Application by Net Zero Teesside Power Limited and Net Zero North Sea Storage Limited (“the Applicants”) for an Order granting Development Consent for the proposed Net Zero Teesside project (“the Proposed Development”)

Author Details	
Name	Dr Andrew Boswell
Position	Independent Scientist & Consultant
NZT Registration	20029943
Organisation	Climate Emergency Policy and Planning (CEPP)

POST EXAMINATION CONSULTATION – 6th SEPT 2023

Figure 1: Approximate pre and post net-zero emission reduction trajectories (whole economy)

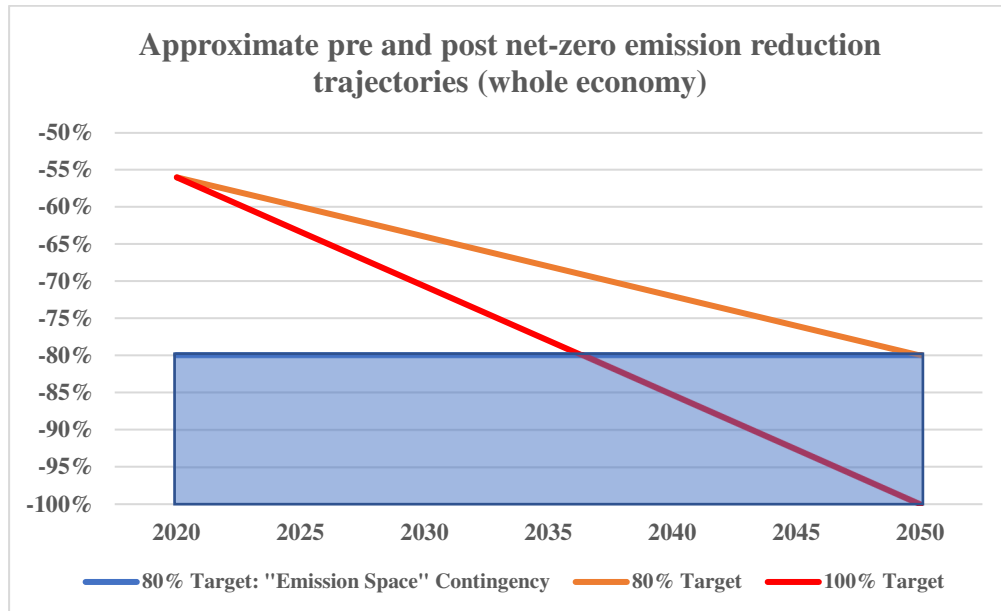
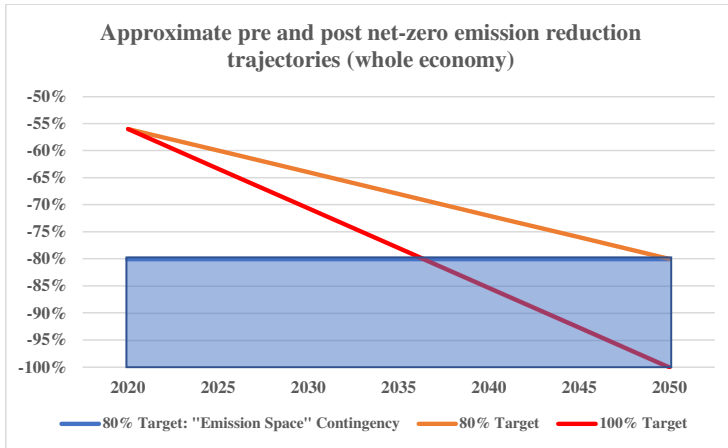
22 I provide the chart below for illustration and to explain three key effects of the legislative change in terms of how the numbers add up, or critically how they may not add up. The chart

23 The keys effects of the legislative change can be seen in the graph as follows:

- (B) The legislated emissions contraction rate via 5-year carbon budgets is extraordinary. The contraction rate (3-4% a year from 2020) for the 100% target (red line) is an approximate doubling of the contraction rate for the 80% target (orange line). The Government's objective is to decarbonise the electricity supply sector by 2035: in 2022, the sector generated 48 MtCO_{2e}, 11% of UK emissions (CCC analysis¹⁰)
- (C) The removal of any on-going background EmSp from 2020. This is most critical effect and the one not usually discussed. It is very relevant to the question of whether there is enough EmSp for the NZT to be developed.

A 20% background level of emissions were legally permitted under 2008 Act until 2050 equating to around c.180 million tonnes of CO_{2e} a year, as indicated by the blue block on the figure. This allowed considerable policy and delivery flexibility that is simply and starkly no longer available: for example, additional emissions from new fossil fuel based electricity generation could possibly have been contained within the 80% at 2050 target if other sectors had rapidly decarbonised, but this is no longer clearly possible.

Figure 2: CCC Progress Report 2023, Fig 4b reproduced

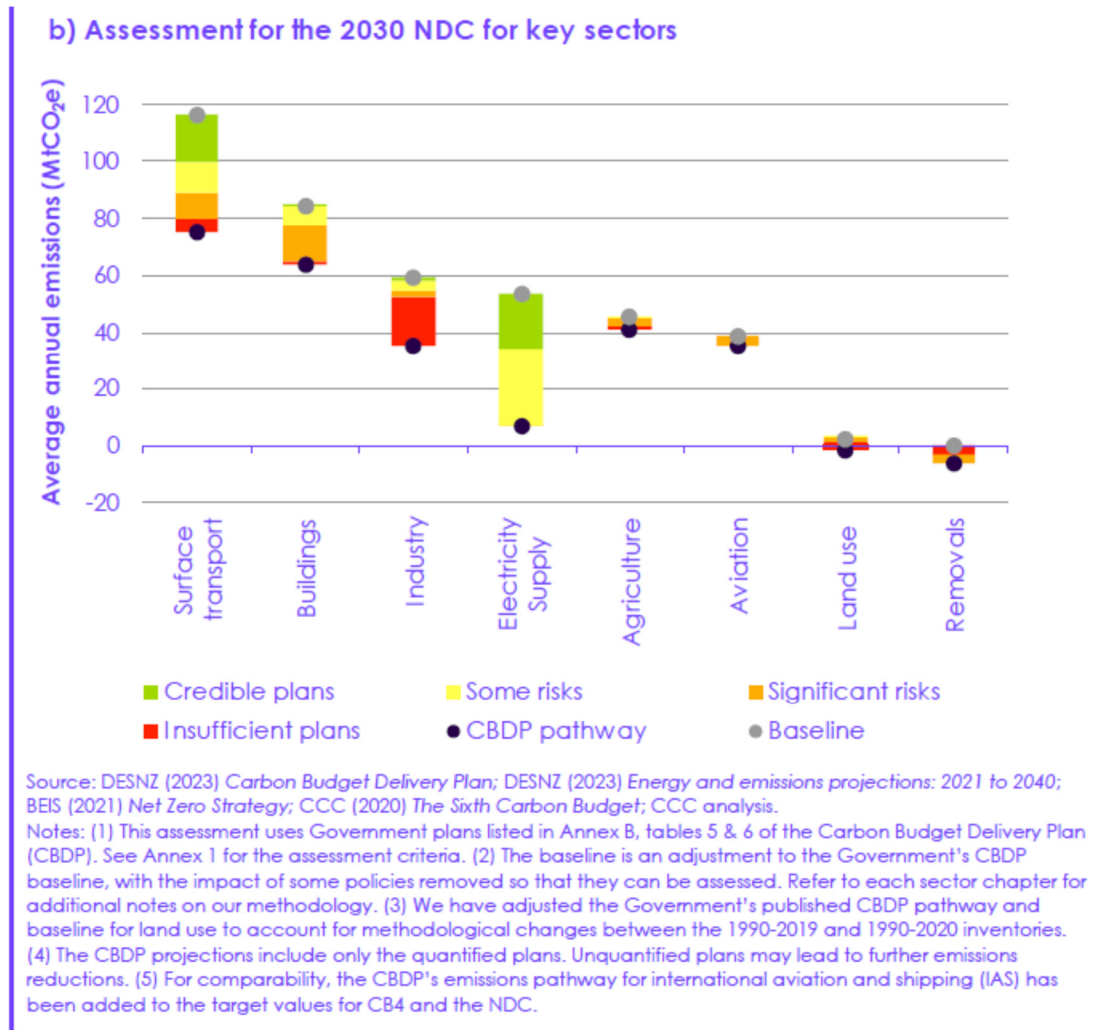
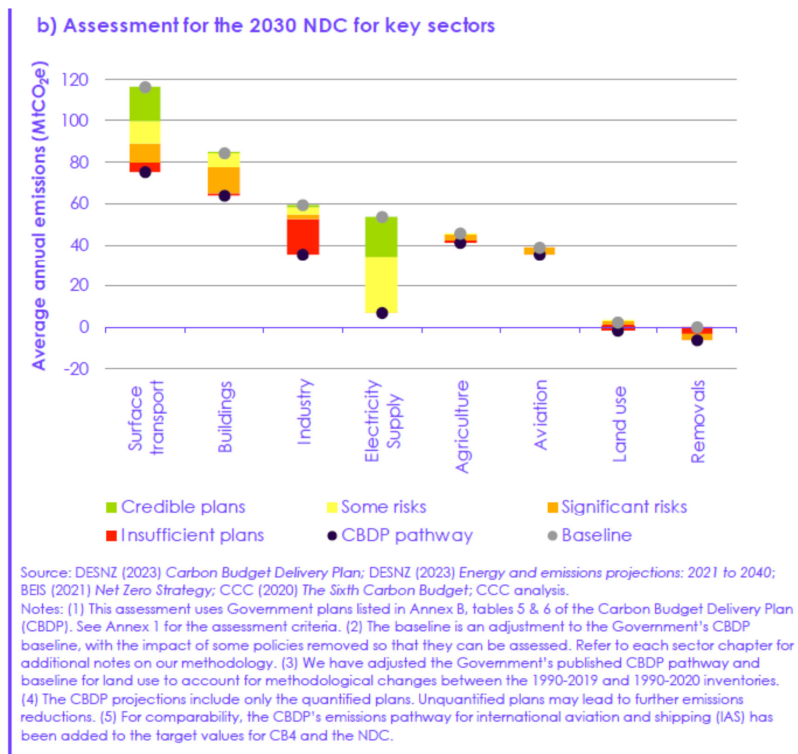
44 Figure 4b on page 24 of CCC_2023_PROG, reproduced below, shows that the electricity supply sector has large emission reductions²³ to make for the 2030 NDC. Electricity supply is required to reduce from a baseline of 53.8 MtCO₂e/yr to 6.7 MtCO₂e/yr (the “CBDP pathway”) in 2030. The CCC assess that credible plans only exist for 41% of this (19.3 MtCO₂e/yr – green on the Figure). There are risks for 27.7 MtCO₂e/yr (yellow on the Figure) of electricity supply emission reductions for the NDC.

45 Note that the Fuel Supply sector is not illustrated on Figure 4b: however, the data is provided in the accompanying spreadsheet²⁴. The Fuel Supply sector is required to reduce from a baseline of 23.9 MtCO₂e/yr to 20.0 MtCO₂e/yr (the “CBDP pathway”) in 2030. The CCC assess that credible plans only exist for 25.5% of this (1 MtCO₂e/yr – equivalent to green on the Figure). There are risks for the remaining 2.9 MtCO₂e/yr of fuel supply emission reductions for the NDC.

Figure 3: CCC Progress Report 2023, Fig 7.7 reproduced

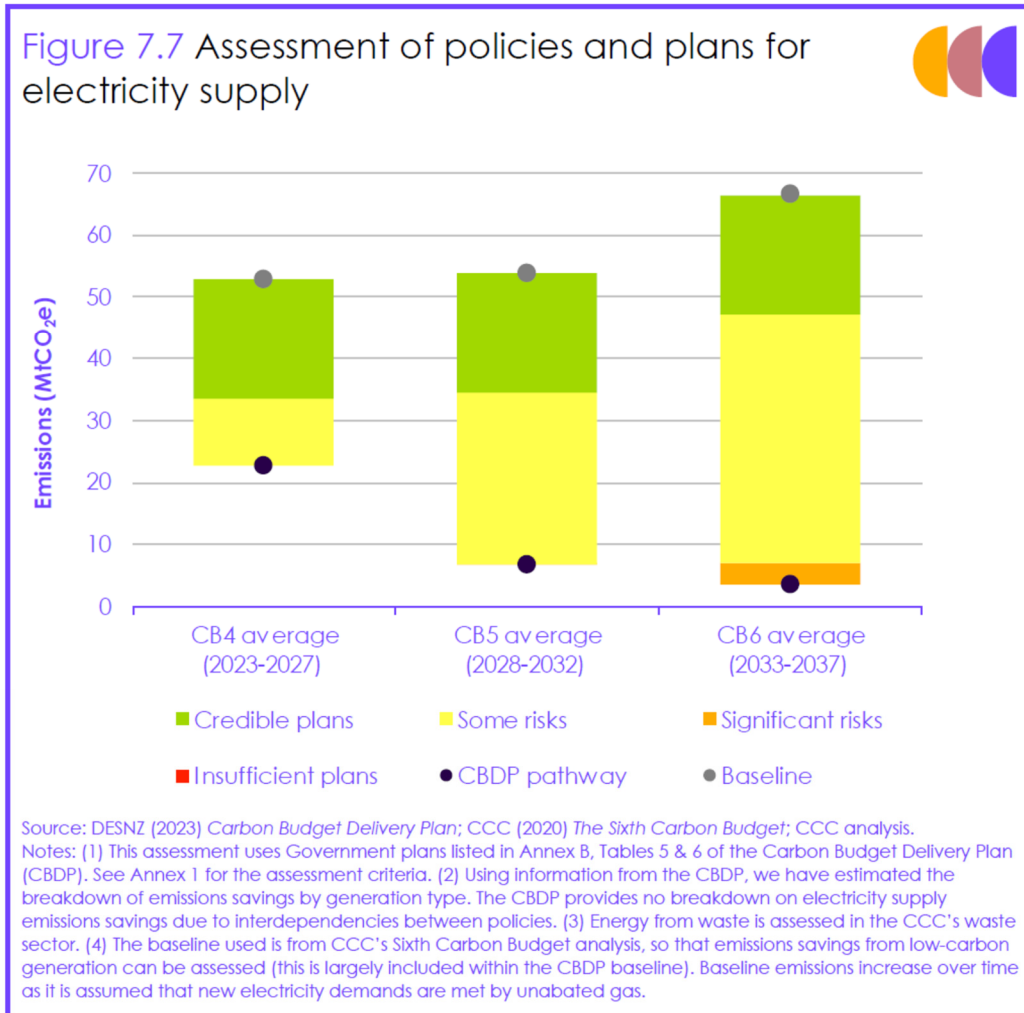
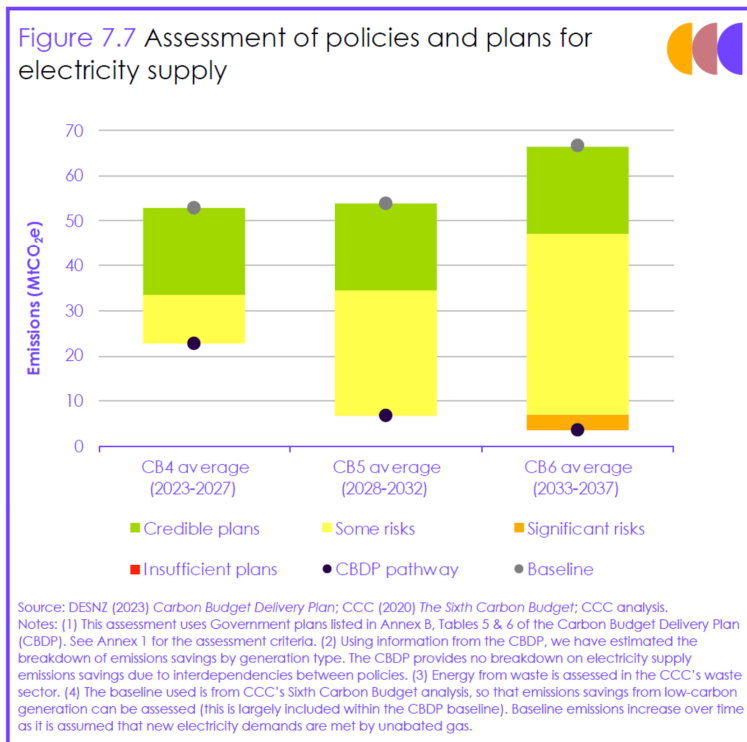
46 Figure 7.7 on page 211 of CCC_2023_PROG, reproduced below, shows the assessment of policies and plans for electricity supply across the 4th, 5th and 6th carbon budgets.

47 For the 6CB, electricity supply is required to reduce²⁵ from a baseline of 66.5 MtCO₂e/yr to 3.5 MtCO₂e/yr (“Government Pathway”). The CCC assess credible plans only existing for

30% of this (19.3 MtCO₂e/yr – green on the Figure). A remaining 43.8 MtCO₂e/yr of electricity supply emissions reductions require to be fully secured in the 6CB.

Figure 4: CCC Progress Report 2023, Fig 8.7 reproduced

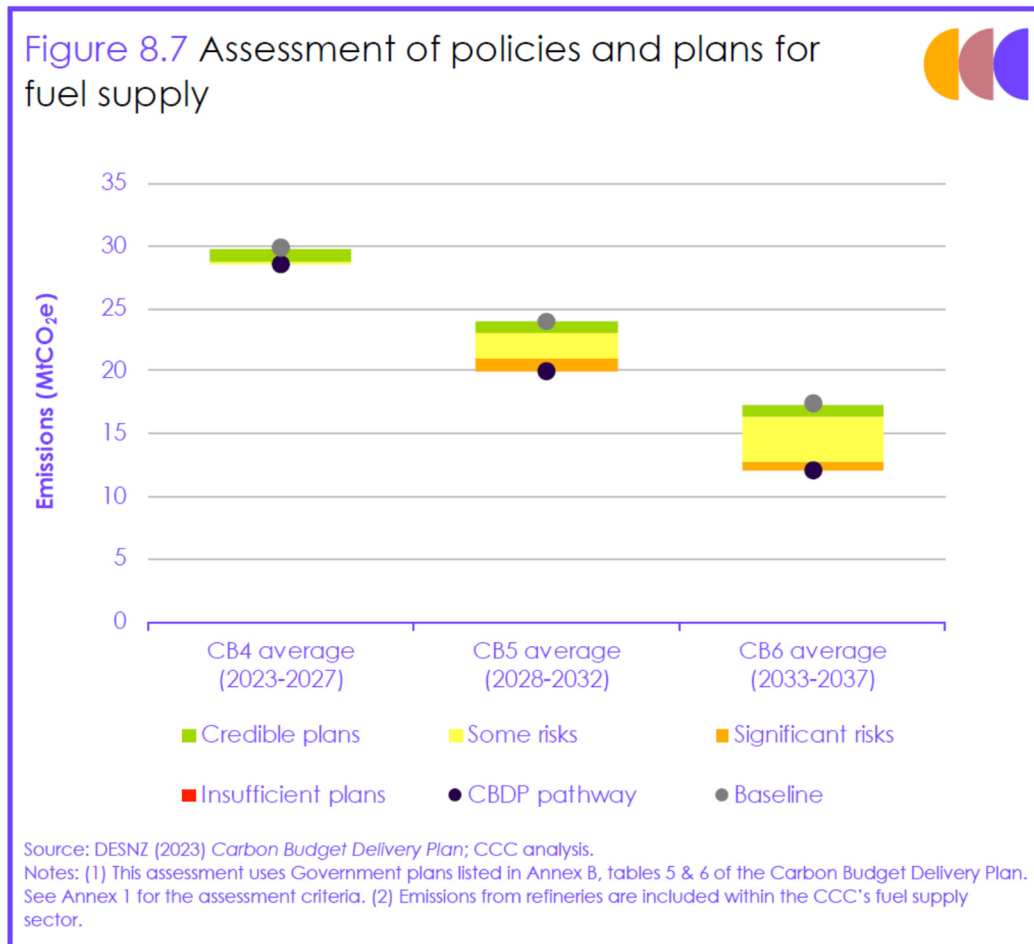
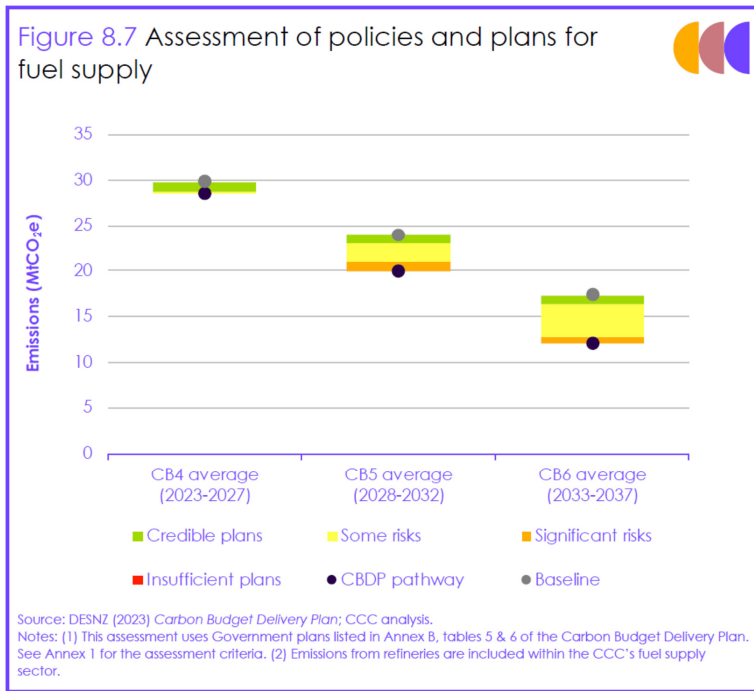
48 Figure 8.7 on page 230 of CCC_2023_PROG, reproduced below, shows the assessment of policies and plans for fuel supply across the 4th, 5th and 6th carbon budgets.

49 For the 6CB, fuel supply is required to reduce²⁶ from a baseline of 17.3 MtCO₂e/yr to 12.0 MtCO₂e/yr (“Government Pathway”). The CCC assess credible plans only existing for 17% of this (0.9 MtCO₂e/yr – green on the Figure). A remaining 4.4 MtCO₂e/yr of fuel supply emissions reductions require to be fully secured in the 6CB.

50 The above reveals the true extent of the “delivery gap” in power/electricity supply, and fuel supply, decarbonisation policy as advised to the Government by their own advisors, the CCC.

Figure 5: Carbon footprint of UK natural gas imports (reproduced from NSTA)

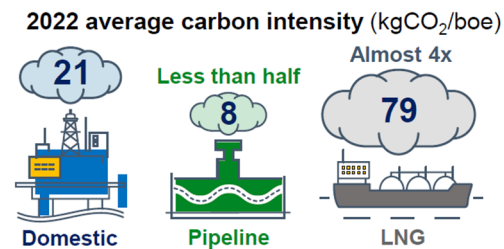
80 Factor (1) was recently highlighted by a methane (natural gas) carbon footprint analysis by the North Sea Transition Authority (NSTA) which showed gas extracted from the United Kingdom Continental Shelf (UKCS) has an average emission intensity of 21 kgCO₂e/boe; whereas imported LNG has a significantly higher average intensity of 79 kgCO₂e/boe (ie: on average 4 time greater). The NSTA fact sheet is reproduced in Appendix A with a diagram illustrating the point above, reproduced below.

81 Consider with Factor (2), the fuel source location, the NSTA analysis shows that in 2022 the UK used 38% of methane from UK sources, and 14% from the US. However, when the CO₂e emissions were estimated from these sources, the US LNG supplies generated 35% of upstream emissions compared to 24% for the UK supply (see “2022 UK gas supply and emissions” in Appendix A). In other words, the upstream emissions were dominated by high methane leakage in supplies from a relatively small total of the gas used in the UK.
